**ADDENDUM TO THE PLANT 6 WORK PLAN TO  
ADDRESS THE TREATMENT OF MOTOR BAY  
SUMP WATER IN THE PLANT 8 VOLATILE  
ORGANIC COMPOUND (VOC) TREATMENT  
SYSTEM**

**DOE-0189-93  
DOE-FN/EPA  
2  
LETTER**

**ADDENDUM NO. 1 TO THE PLANT 6 CONTAMINATED PERCHED WATER MODIFIED REMOVAL ACTION WORK PLAN**

PROCESS FLOW DIAGRAM  
PERCHED WATER REMOVAL ACTIONS  
PLANTS 2/3, 6, 8, & 9

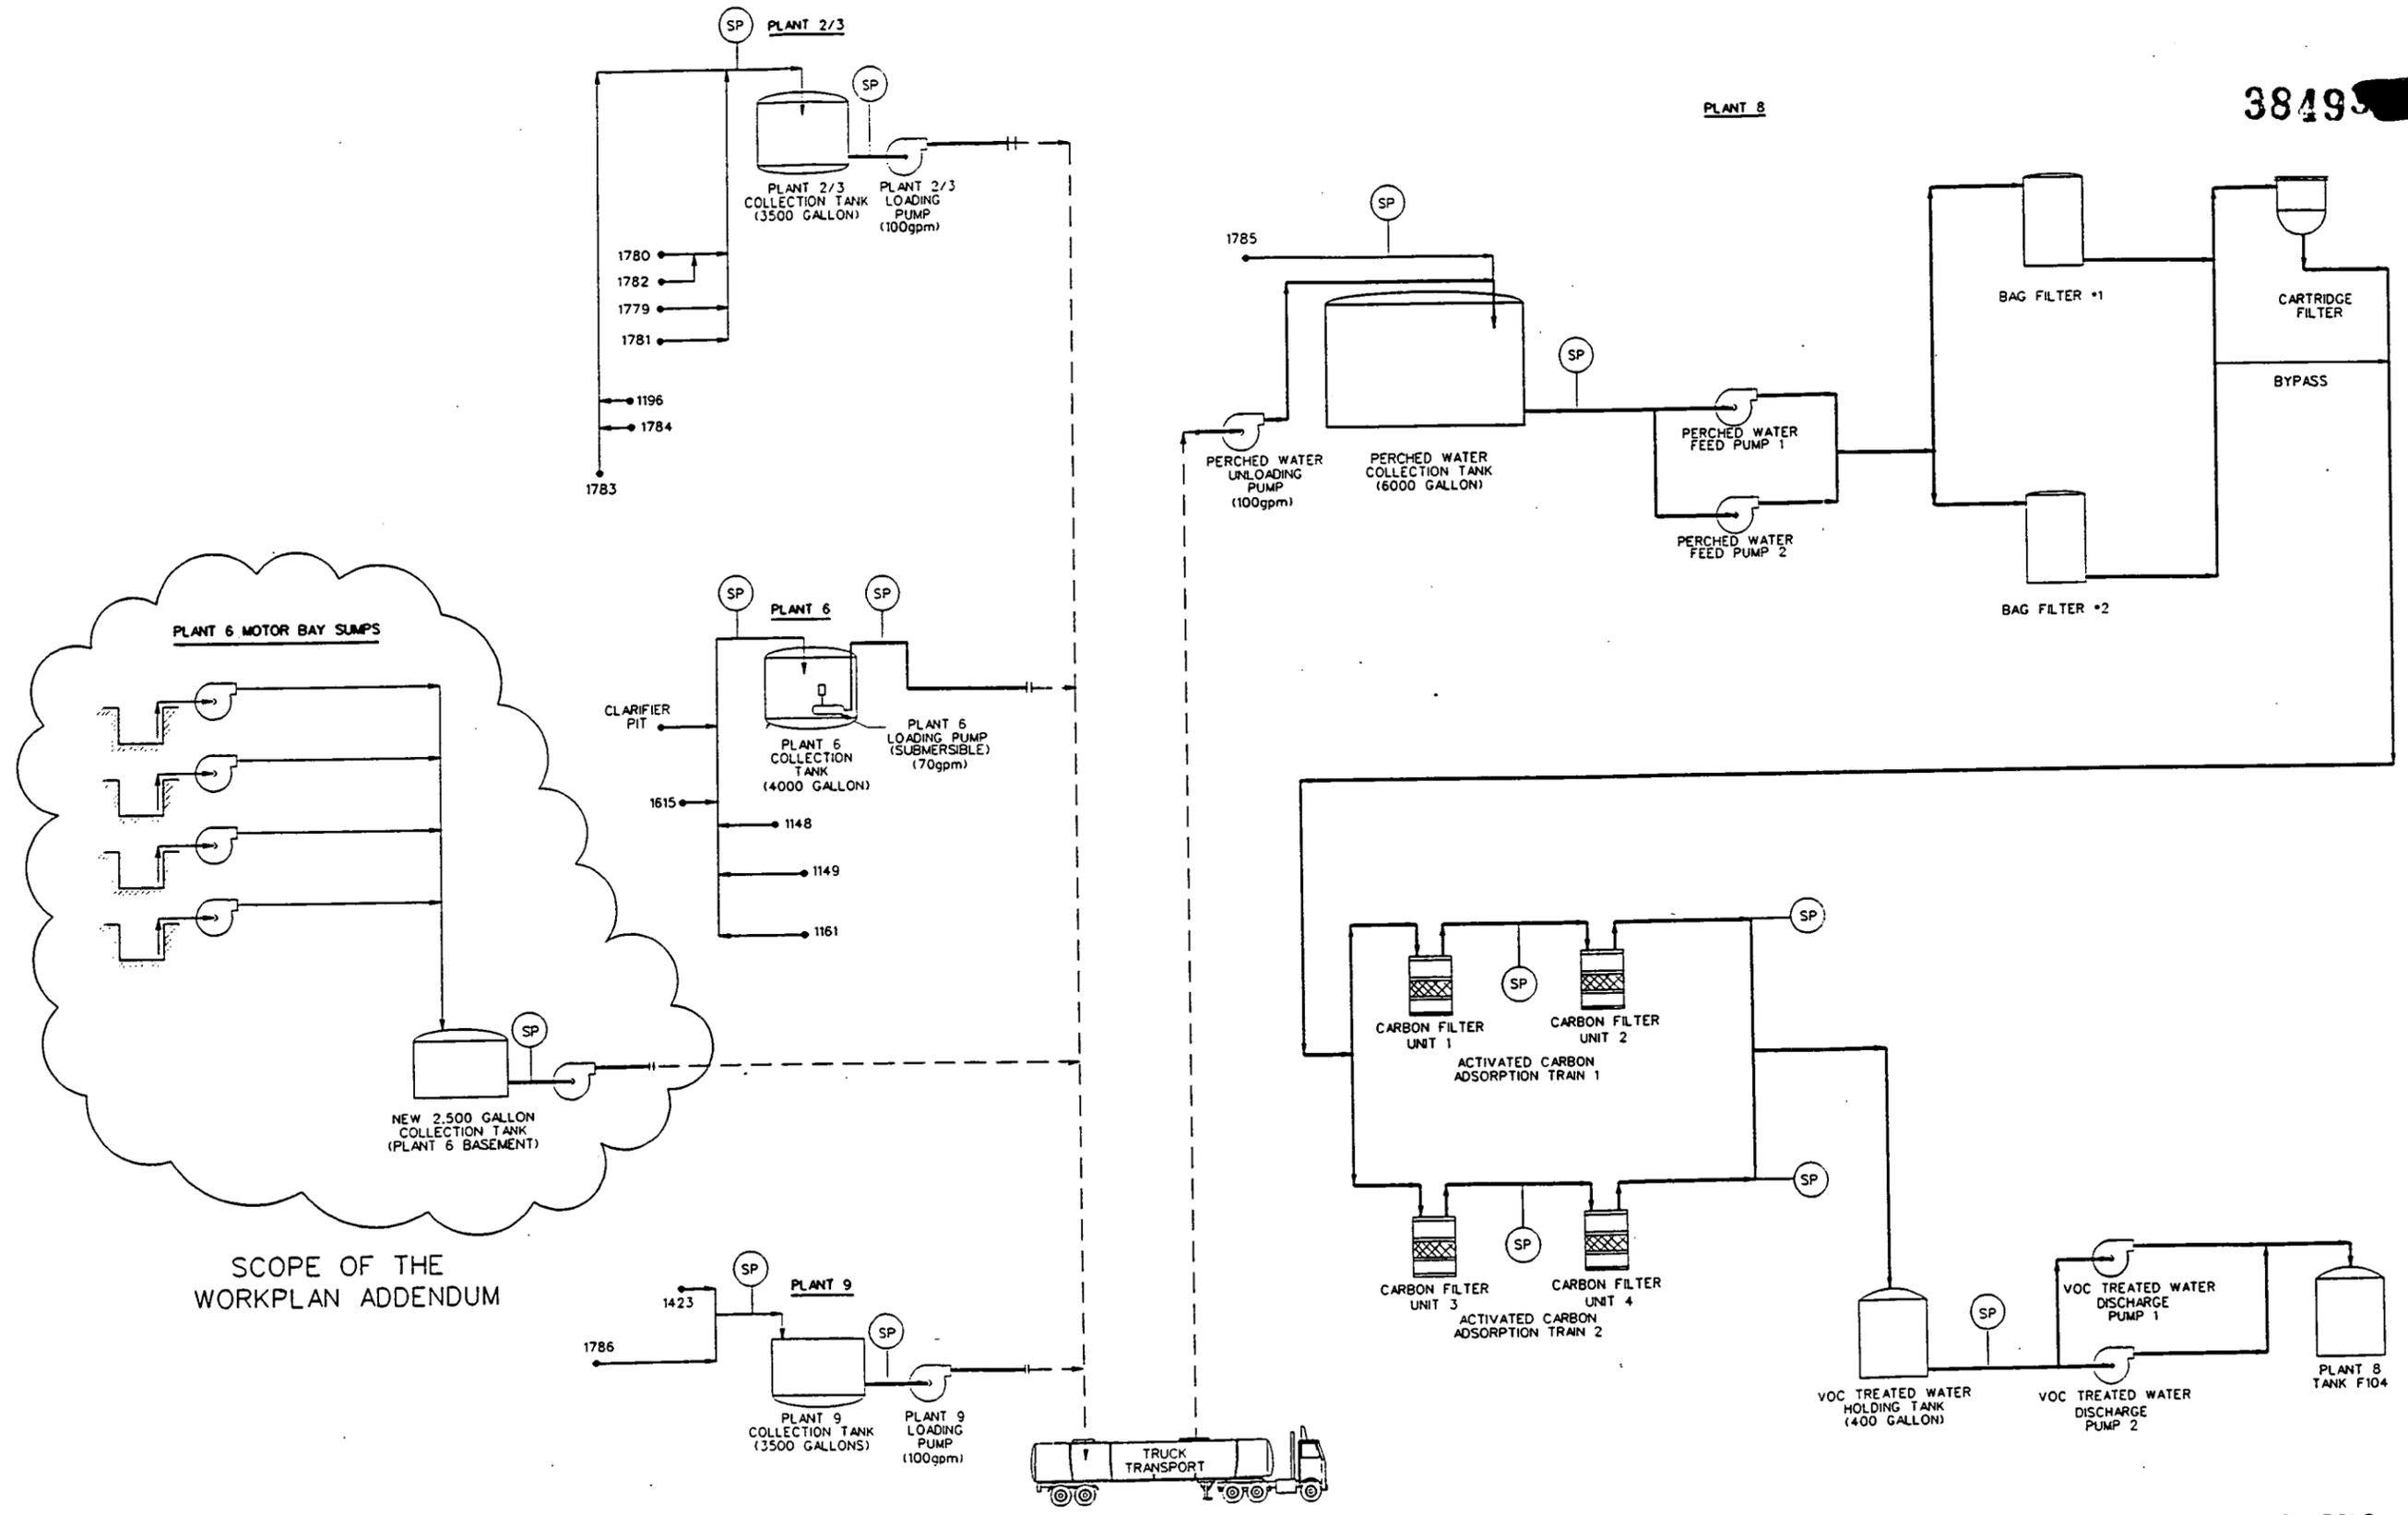
In order to facilitate the additional pumping and storage required to treat the Plant 6 waters collected in the Motor Bay Sumps, several modifications to the existing system are required. A new storage tank will be installed in the basement of Plant 6 adjacent to the four sumps. The placement of this holding tank in the basement of Plant 6, rather than at grade, will allow the collection system to utilize the existing four Motor Bay Sump pumps. A new unloading pump will be installed to enable emptying of the new storage tank into the existing tanker truck used to transport the perched water to the Plant 8 VOC treatment system. Enclosed is a flow diagram illustrating the incorporation of the additional streams into the existing flow to the Plant 8 VOC treatment system.
